MEMORANDUM

From:	Tina Cuss Ecology Officer		
Service	WBC Ecology	App No:	261182
Address:	12 South Drive, Sonning, Wokingham, RG4 6GB.		
Proposal:	Householder application for the proposed erection of a two storey front and side extension, part single storey part two storey rear extension, single storey rear extension with pitched roof, erection of terrace, garage conversion to create habitable accommodation plus changes to fenestration and erection of front gates.		
Type of Development:	Other Householder		
Site Visit Made:	No

Figure 1. Preliminary Roost Assessment findings plan.

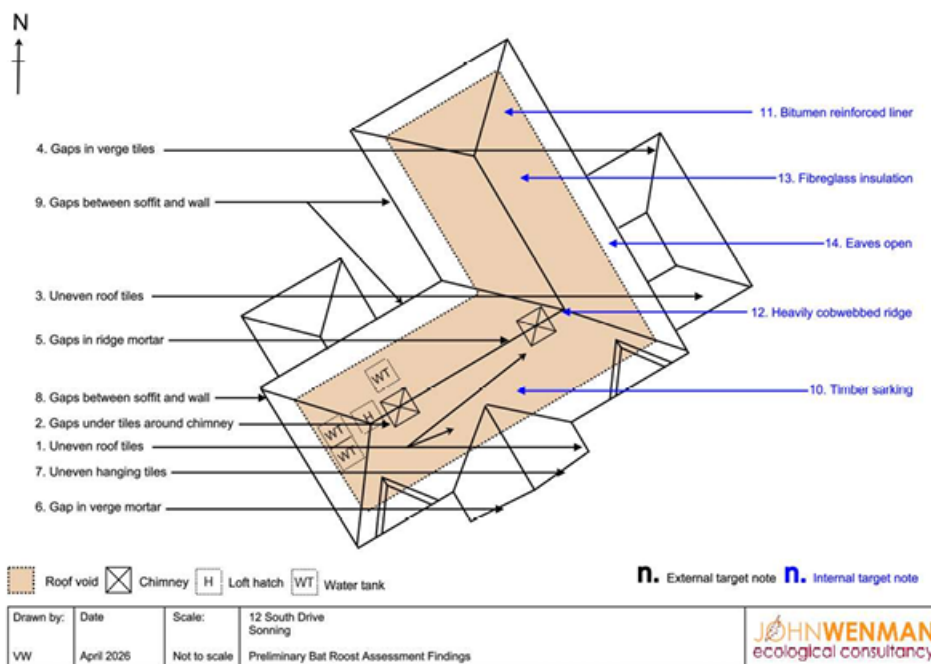
The PRA inspection carried out on 1 April 2026, identified several features which could provide opportunities for crevice-dwelling bats. These included raised and

uneven roof tiles, gaps in ridge and verge, gaps behind uneven hanging tiles and between overhanging timber eaves and walls. The quantity of raised and uneven roof tiles, particularly those running along the verges, the uneven hanging tiles, gaps in the ridge and verge mortar and gaps between the overhanging timber soffit and wall, could lead to potential roosting sites for crevice dwelling bats between the timber sarking, bitumen liner and roof tiles, such as the common pipistrelle (. Evidence of crevice-roosting species is typically hidden from view in areas such as gaps between tiles and internal linings/insulation. The Ecologist notes it is not always possible to inspect all potential roost sites, particularly for roost in hidden crevices. Therefore, an absence of bat evidence found during a survey does not necessarily equate to evidence of bat absence in a building.

I note the PRA desk survey did not include local bat group or record centre bat roost data. The planning history search failed to include the record for a potential bat emergence from 12 South Drive recorded in 2020 (Ref 200757), as well as the bird and/or bat boxes which the LPA previously secured at 12A South Drive. In addition, local records include multiple roost records on Bath Road to the south, Sonning Meadows to the north as well as roosts to the west on South Drive.

While the number of local roosts has not been fully considered, I agree with the Ecologist's conclusion that the shed has negligible potential, and the house has moderate potential suitability. The development proposals will directly impact several potential bat roosting features and could lead to direct and/or indirect disturbance, injury or death of bats. I agree that further surveys needed a minimum of two dusk emergence survey need to be undertaken in the period of May to August to determine the impact of the proposals on protected species. If the emergence surveys record roosting bats, further surveys will be required to characterise the roost and inform an impact assessment and mitigation strategy. I broadly support the recommended mitigation and enhancement set out in PRA section 8.
